## 2.0 REVISED PROJECT DESCRIPTION

In response to public, Planning Commission, and City Council comments made following the December 2020 release of the RDEIR, Davidon Homes has made further revisions to its Davidon (28-Lot) Residential Project component. With these revisions, the residential component would continue to provide 28 single-family residences, but would use no natural gas, would reduce the acreage of residential lots and associated streets from approximately 11.7 to 6.4 acres, would provide 5 acres of private open space, and would increase the acreage of the Putnam Park Extension Project component from approximately 44 to 47 acres. This would be accomplished by reducing residential lots size and residence size, locating more residential lots north of Windsor Drive, and eliminating residential lots south of the proposed “B” Street. These changes would also increase the distance between the proposed residential development and Kelly Creek, reduce impacts to California red-legged frog habitat and native grasslands, reduce total grading area and volume, and reduce total energy and water use for the residential component.

Revisions to the **RDEIR Section 3.0, Project Desc

UPDATED FIGURE **3.0-11**

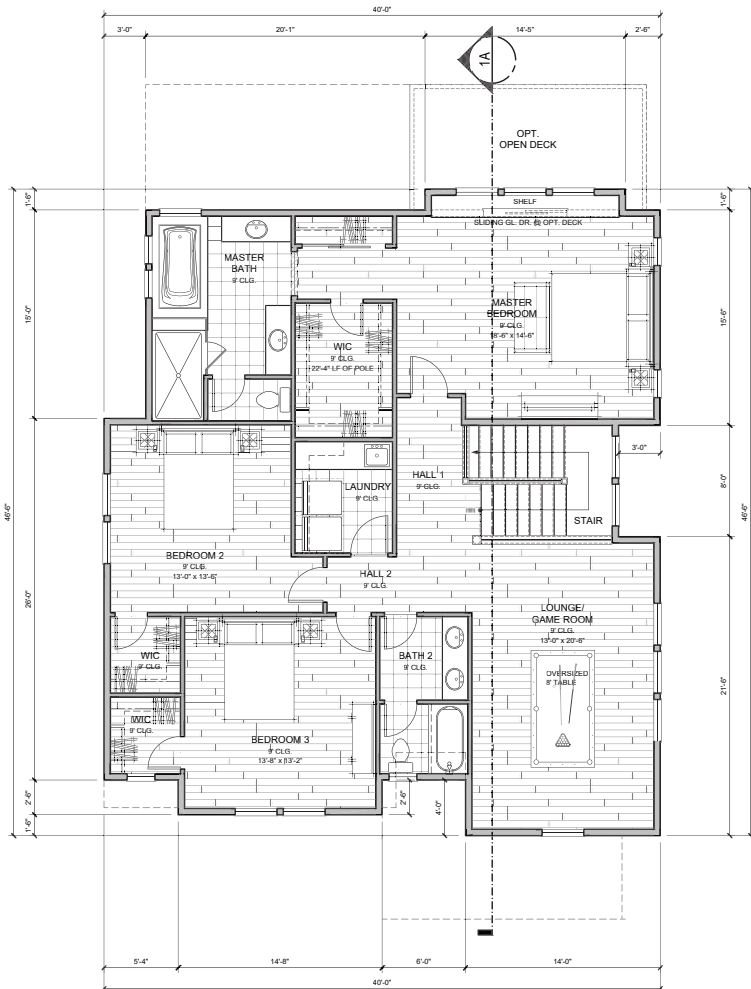
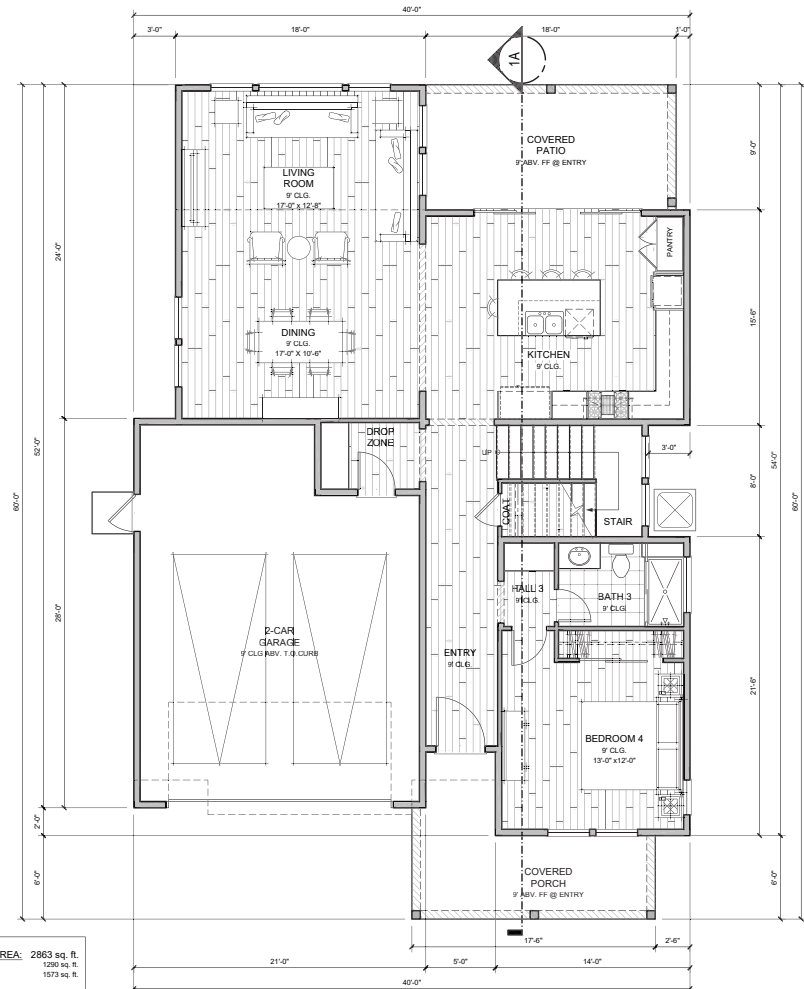
The minimum lot size would be ~~5,800~~~~10,000~~-square feet (sf) while the average lot size would be ~~7,433~~~~11,245~~-sf. As shown in **Table 3.0-2, Characteristics of the Proposed Single-Family Residences**, the residences would range in size between ~~2,489~~~~2,678~~-sf and ~~3,380~~~~3,523~~-sf and would be constructed in three potential floor-plan configurations: ~~2,489~~~~2,678~~ sf single-story (~~10~~ residences), a ~~2,863~~~~2,928~~ sf single two-story (~~9~~ residences), and ~~3,380~~~~3,523~~ sf two-story (~~9~~ residences, each including a junior Accessory Dwelling Unit (ADU)) plans (**Figures 3.0-11 through 3.0-13**). In total, there would be ~~10~~ ~~21~~ single-story and ~~18~~ ~~7~~-two-story homes. Each configuration would have three different elevations. Architectural styles of the residences would include ~~Spanish Cottage~~, Craftsman, Farmhouse or California Ranch (**Figure 3.0-14, Architectural Styles**). Architectural detailing of ~~mosaic tiles, iron elements, shutters, accent corbels, enhanced window treatments and front porches with railings and precast concrete~~ would be utilized to enhance the front elevations. Exterior materials would include a mix of stucco, hardboard siding, cultured stone, and masonry. ~~All~~~~r~~Roofs would be made of concrete tile ~~with some including metal roof detailing. All roofs would incorporate solar panels consistent with the state's zero net electricity policy. Solar panels would be installed either on hooks or using composite shingle. Hooks would be installed under the concrete tiles. Composite shingle would replace the concrete tiles during installation and would not be visible.~~ Indoor and outdoor lighting would be installed in and around the single-family homes. The lighting would conform to the requirements of the City of Petaluma Implementing Zoning Ordinance (IZO) Section 21.040.D to control glare.

UPDATED FIGURE **3.0-16**

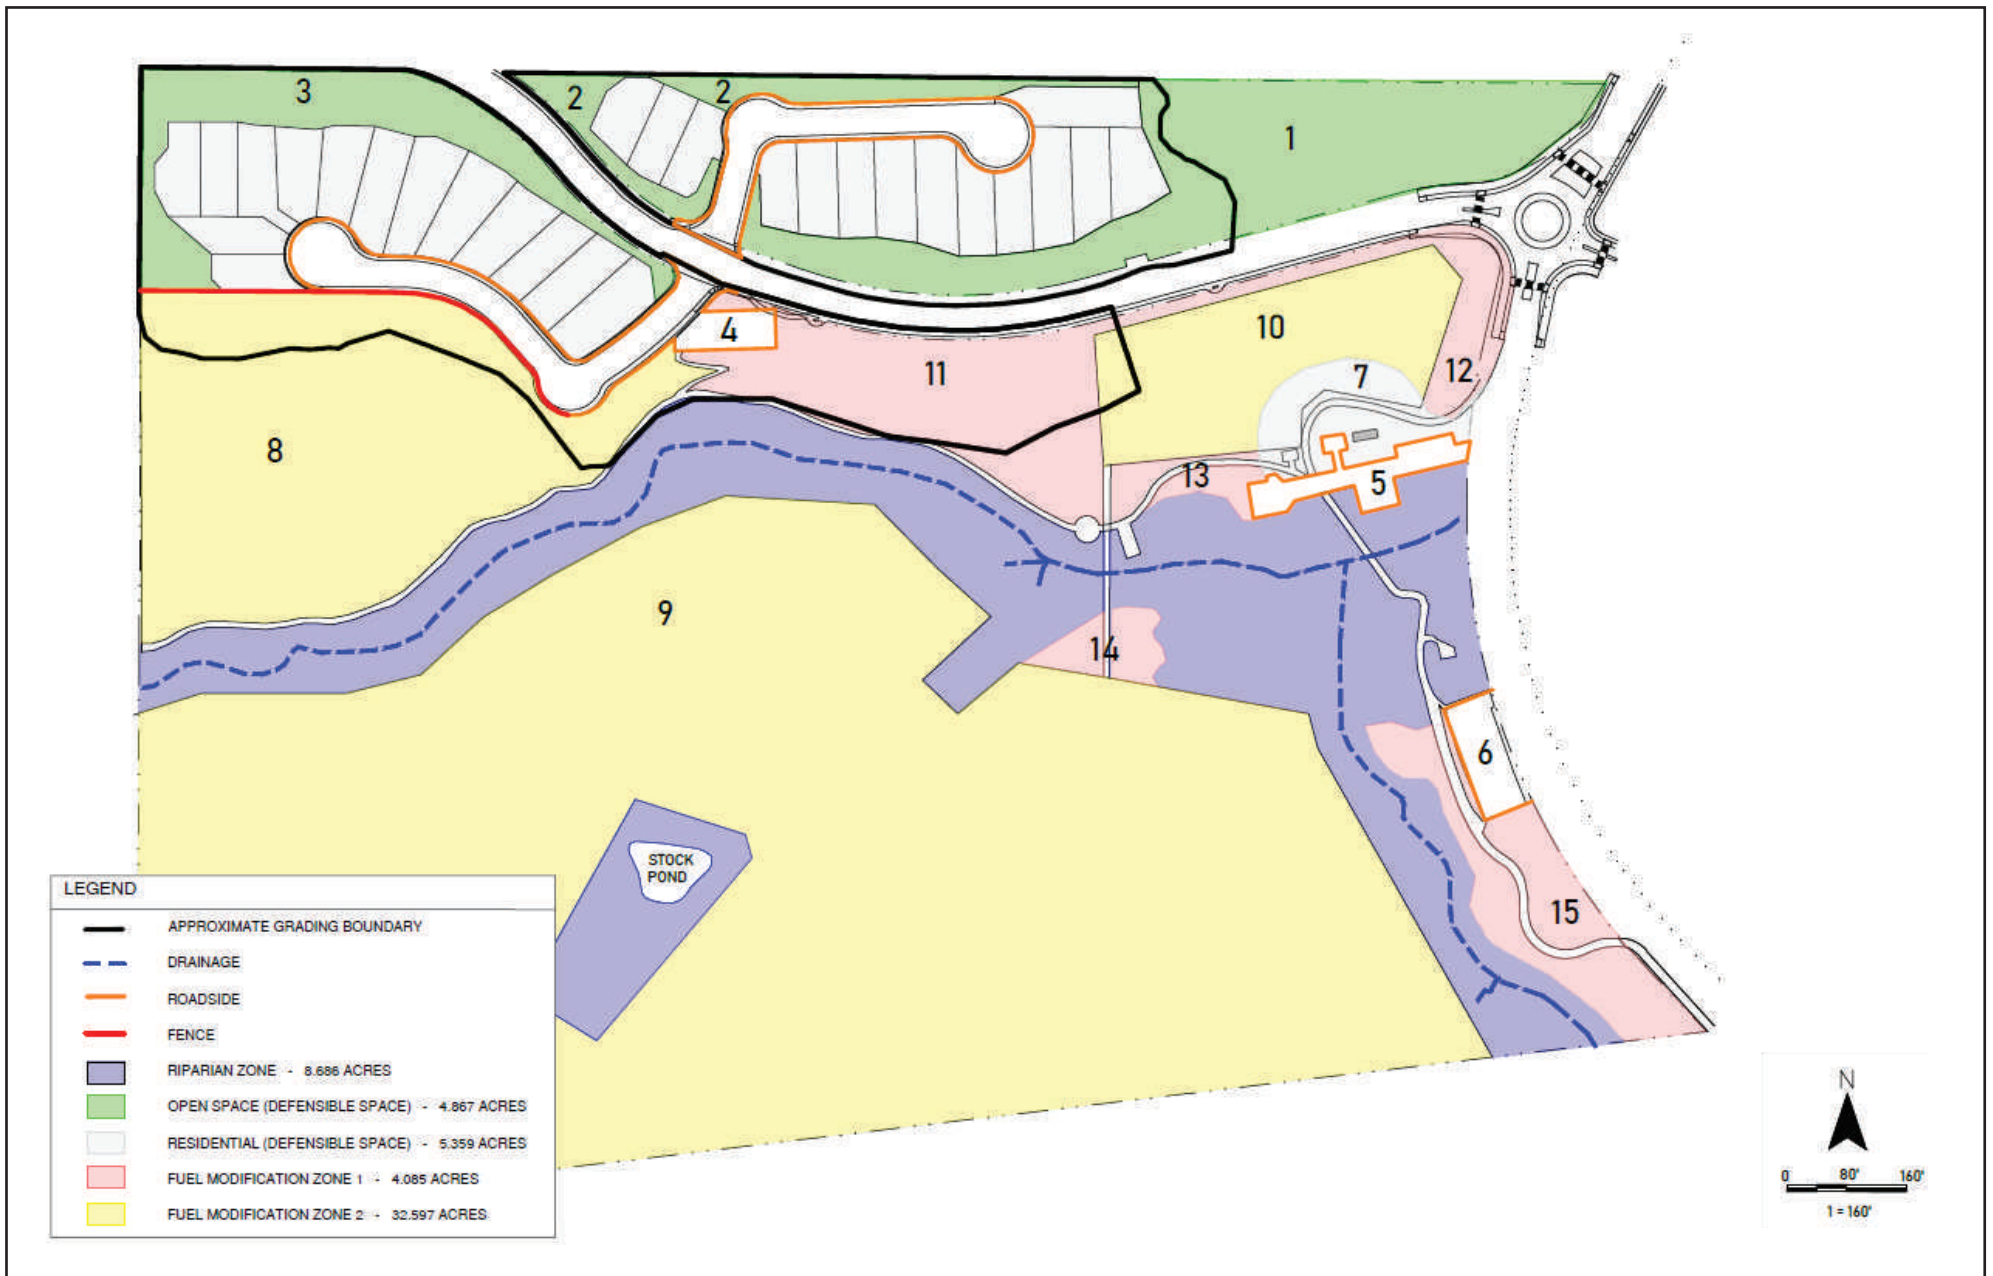
As shown on **Updated Figure 3.0-16, Fuel Management Zones**, the Fuel Management Program delineates six treatment zones:

- Open Space Defensible Space Zone (green)
- Roadside Vegetation Management Zone (orange boundary line ~~blue~~)
- Fuel-Modification Zone 1 (~~yellow~~ tan)
- Fuel Modification Zone 2 (~~tan~~ yellow)
- Riparian Zone (purple)

The **Roadside Vegetation Management Zone** consists of vegetation near roads, driveways and parking lots, and is designed to assist evacuation and emergency vehicle access and to limit ignitions from vehicles. It is shown in ~~blue~~ an orange boundary in **Updated Figure 3.0-16** (Areas 4, 5, and 6-8, and 10) and also applies along Streets A and B. The standards and actions to comply with both the Residential Defensible Space/Landscaping Zone and the Roadside Vegetation Management Zone are the same, with one exception. in the Roadside Vegetation Management Zone there must also be a 15-foot vertical clearance created by tree-trimming over pavement along the entire length of the roadway, parking lot, or driveway.

**Fuel Modification Zones 1 and 2** encompass the remainder of the open space portion of the project site, and ensure the fuels do not exacerbate fire hazards to adjacent landowners and structures. Fuel Modification Zone 1 (~~tan~~ yellow) is within the ~~fenced cattle grazing area portion~~ of the proposed Helen Putnam Park Extension where any cattle grazing is most likely to occur and is designed to limit fire intensity and spread by means of the pruning of trees, reduction of understory plants, and use of prescribed grazing activities. Fuel Modification Zone 2 (~~yellow~~ tan) is also within the proposed Putnam Park Extension Project component, but is outside the ~~regular~~ most likely cattle grazing area;
